McCULLOCH SERVICE BULLETIN

NO. 1574

MODEL Mini-Mac 30, 35 DATE September 16, 1974

SUBJECT IMPROVED THROTTLE TRIGGER

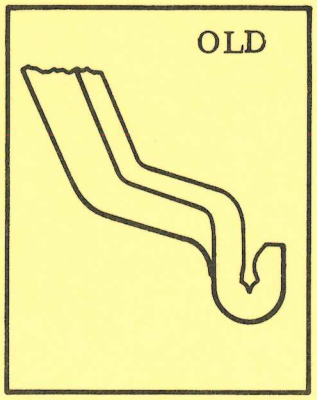
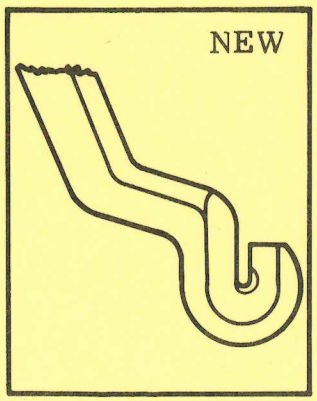
Trigger, P/N 83878, has been improved to provide better retention of the rod. With this improvement, the clip described in Service Bulletin #1560, to retain the throttle rod in the trigger, is no longer required. The improved Trigger, P/N 83878, was first installed in Mini-Macs as follows:

The old and the new trigger may be identified by the shape of the slot end as illustrated below.

The new trigger will backfit on all Mini-Mac saws which used the old trigger.
